## Matthew Rosel - Submission Details for Donald Sharp (object)

Submission for Job: #5878 SSD 5878-2013 Sydney International Convention, Exhibition and Entertainment Centre Precinct - Mixed use Development in the Southern Haymarket Precinct (Concept Proposal)  
[https://majorprojects.affinitylive.com?action=view\\_job&id=5878](https://majorprojects.affinitylive.com?action=view_job&id=5878)

## **Group submission relating to application SSD 5878**

### **Sydney International Convention, Exhibition and Entertainment Centre Precinct – Mixed use Development in the Southern Haymarket Precinct (Concept Proposal) (SSD)**

*“Development application, Peak Tower, North Elevation, proposed building profile overlay*

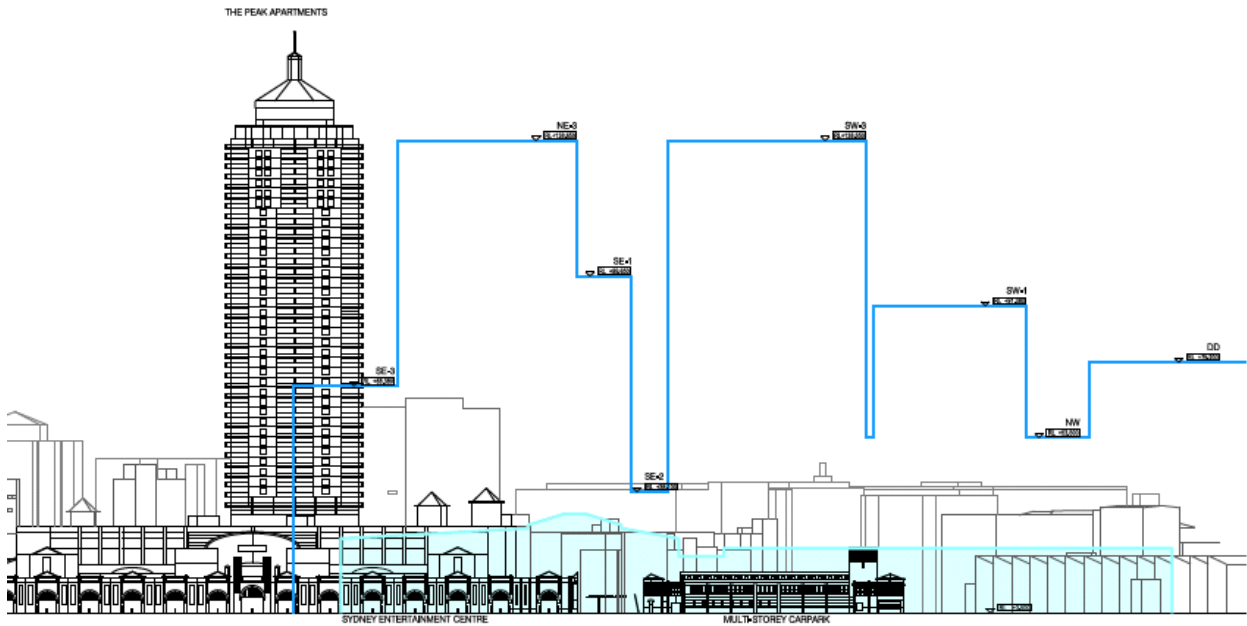
### 3. Parts that are relevant only to the Haymarket precinct are buried in the SICCEP DA.

Are these errors or just a convenient place to hide them ?

The following figure – buried in SSD 5755 illustrates the size of the proposal in relation to The Peak.

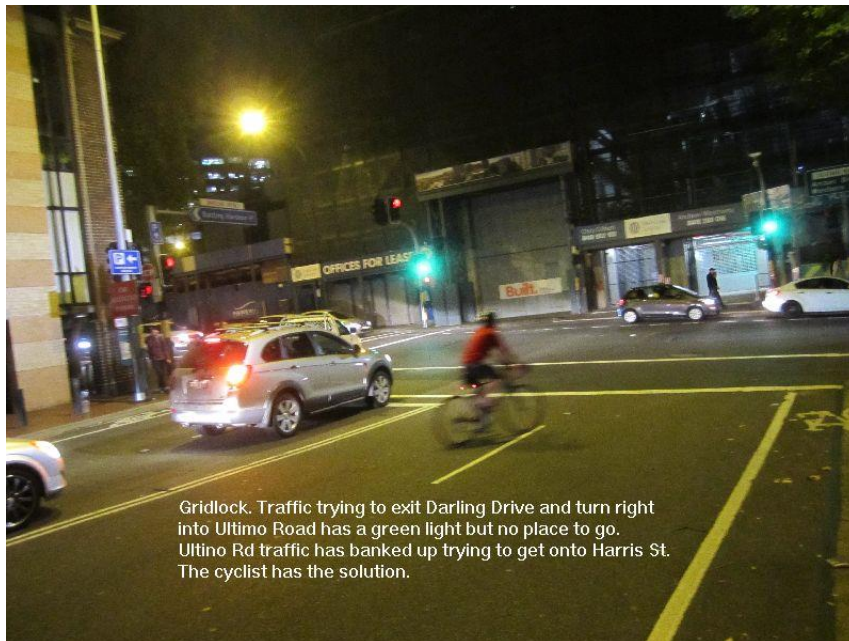
Darling Drive will be reduced to one lane each way EIS 2/4 P71: “ Darling Drive has reduced the number of lanes and tightened the road corridor to provide a more attractive setting for the student accommodation”

One of those is at Ultimo Rd, where the study states that 30% of the traffic flow to and from Darling Drive will be via Ultimo Road (section 7.1.1). Yet amazingly no traffic studies are done on this intersection !

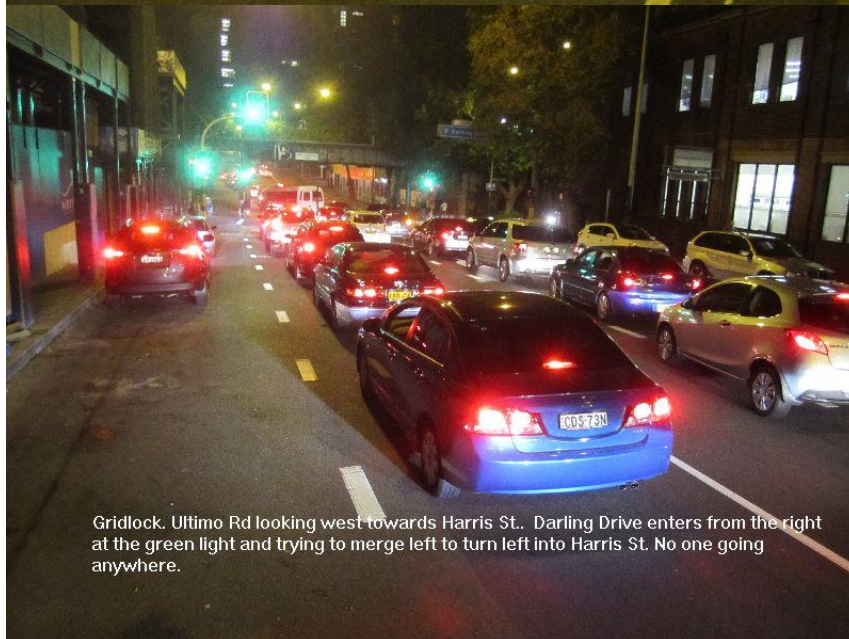
Gridlock. Traffic trying to exit Darling Drive and turn right into Ultimo Road has a green light but no place to go. Ultimo Rd traffic has banked up trying to get onto Harris St. The cyclist has the solution.

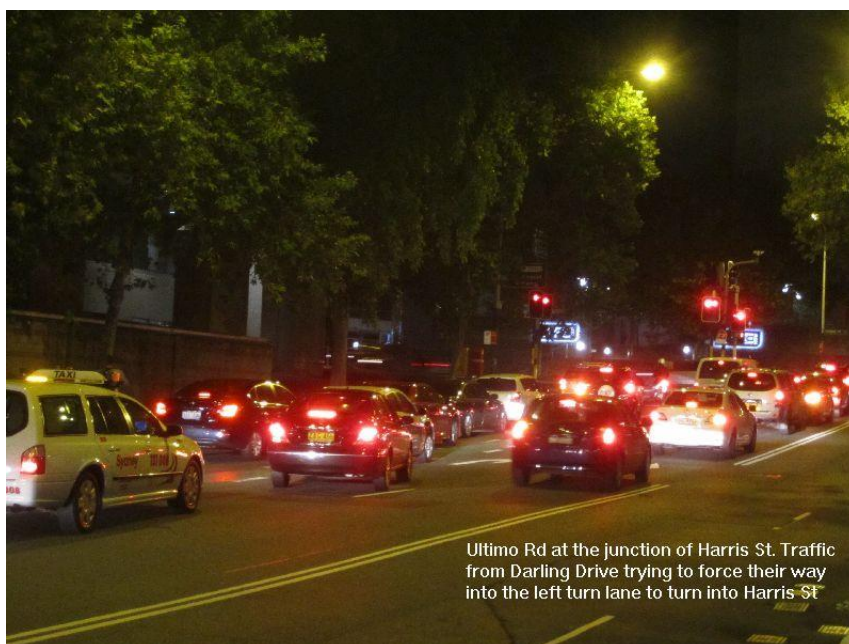
Gridlock. Ultimo Rd looking west towards Harris St.. Darling Drive enters from the right at the green light and trying to merge left to turn left into Harris St. No one going anywhere.

Ultimo Rd at the junction of Harris St. Traffic from Darling Drive trying to force their way into the left turn lane to turn into Harris St

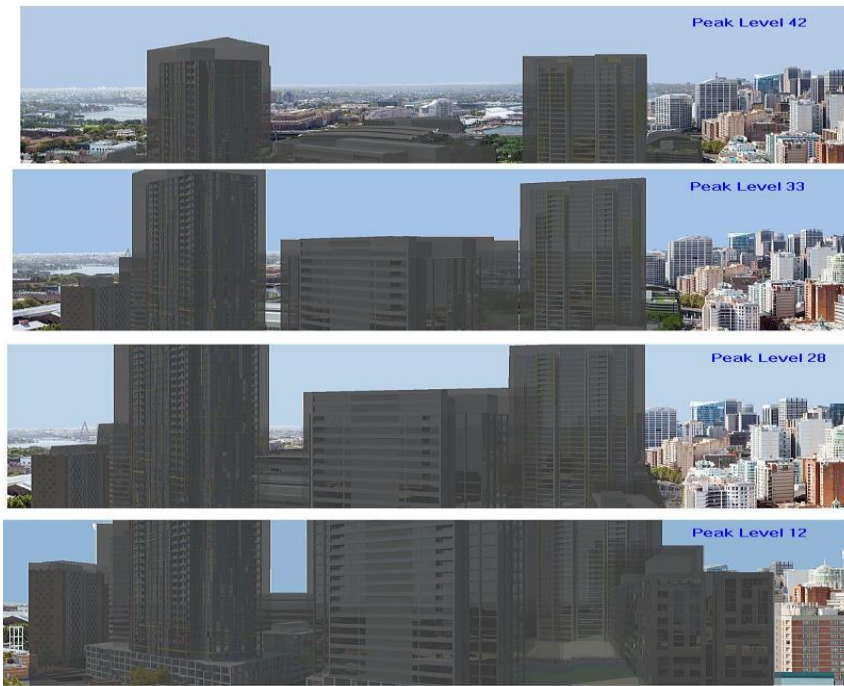
- Does not respect privacy and overlooking.
- Does not respect view sharing with existing buildings: 231 units in the Peak alone will lose an average of 60 degrees of views.
- Does not differentiate between new public views and new private views when preference should be considered for the **public** good.
- Proposes nine towers south of Pier St, where the Woods Bagot report suggests 2 and the City of Sydney recommends only 3
- Does not introduce setbacks for towers
- Does not allude to any concept of human scale

DMC acknowledge and restate those principles (Design Report p 50) and add that *“Towers are to be slender in form and should not come to the ground, but rise from urban blocks”* and then design virtually every tower originating with a sheer wall from the street !

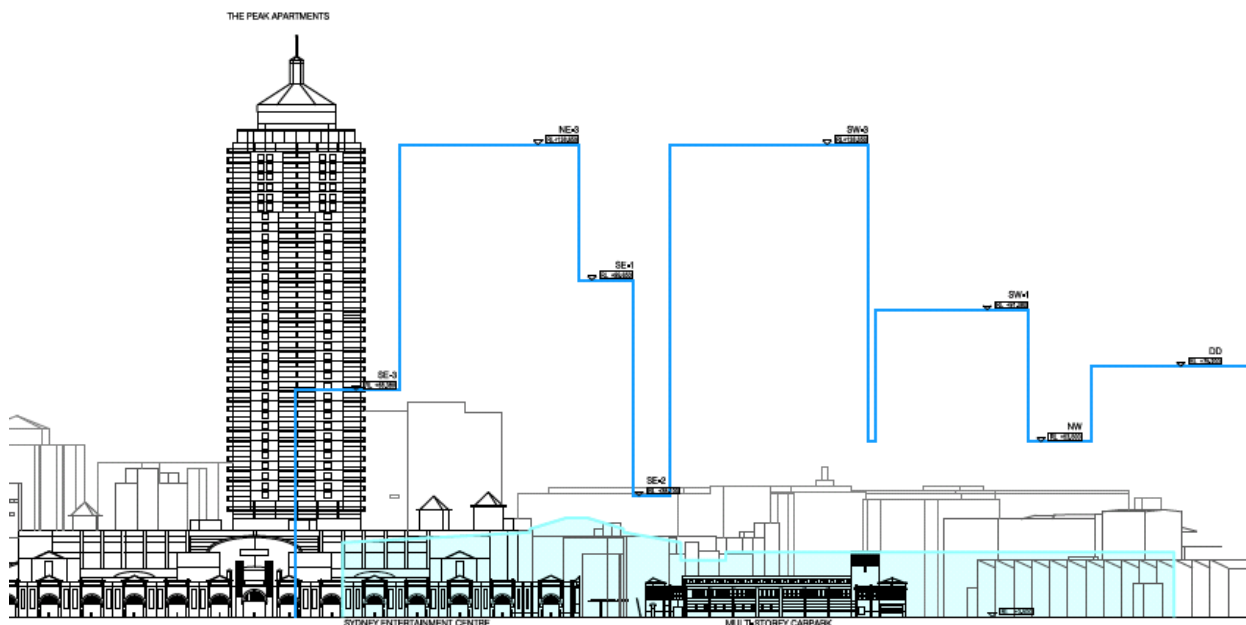
This shows these planning guidelines have been ignored in the drive for increased density and optimum placement of the new towers for maximum return - all with scant regard for the existing buildings.

The loss of amenities, outlook and views is an excessive burden on the residents of the Peak and for all the residents of surrounding buildings. At a minimum, it is imperative to delete the Tower SE1 from the planned development.

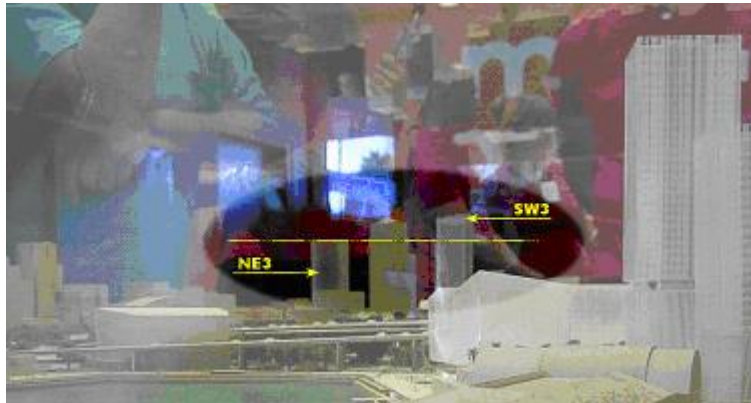
- *Views to the Powerhouse Museum will be affected by the two residential blocks in the Haymarket Precinct situated next to the Rail Corridor, which will also be impacted. Principal views to the Powerhouse Museum are available from Harris Street and will not be affected by the proposed development, while views to the building are of secondary importance.*

The student blocks and tower SW 1 will obscure the sight lines to the Museum from the southwest and the CBD. Why is it deemed sufficient to retain only the western façade when the eastern façade is the most important one.

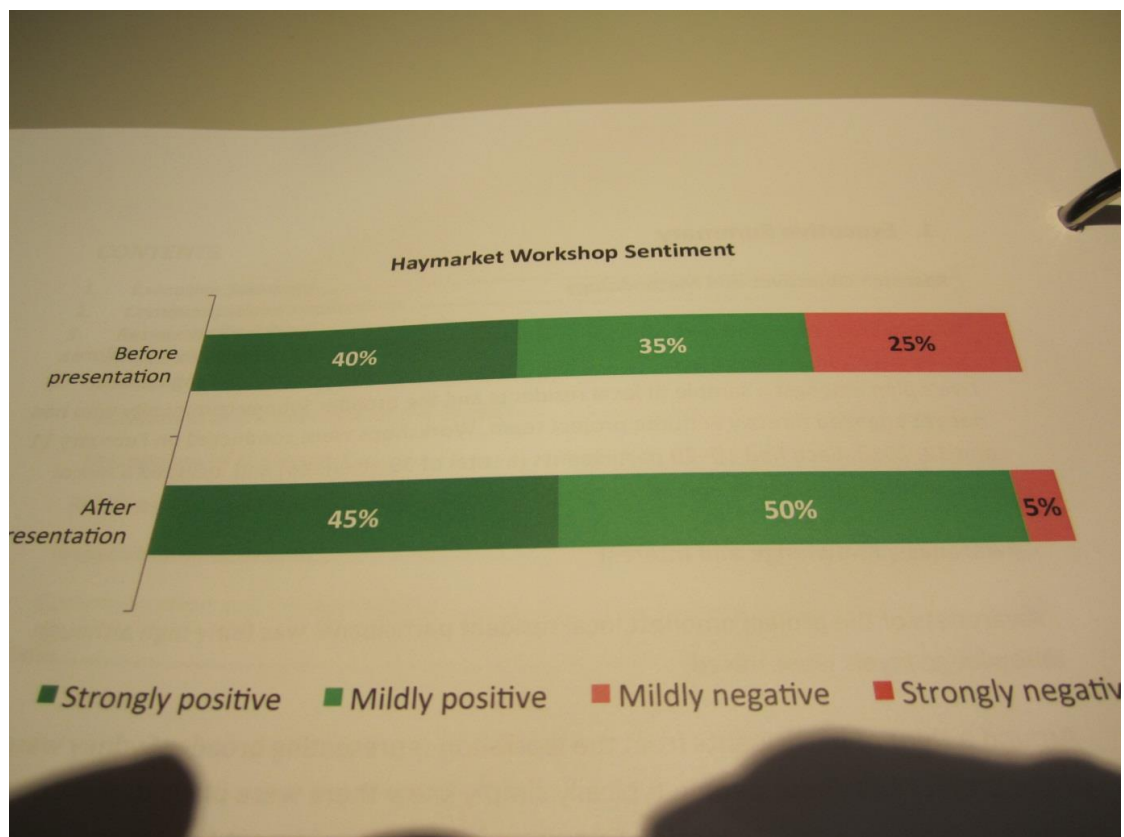
The information given during consultation was very much smoke and mirrors. The statements given on the height of the towers was vague and variable with the number of floors being defined from the podium level in some cases. The RLs of the top of the towers were not disclosed prior to the EIS being lodged. In fact tower NE3 grew about 8 floors after consultation. This is clear from photos of the original model.

It is claimed that ‘mildly negative sentiment after presentations was reduced by 20%.’ This is not the impression of those who attended the meeting. Many walked out in disgust when it was fairly blatantly put to them that this was the deal and you could have your say when the DA was posted.
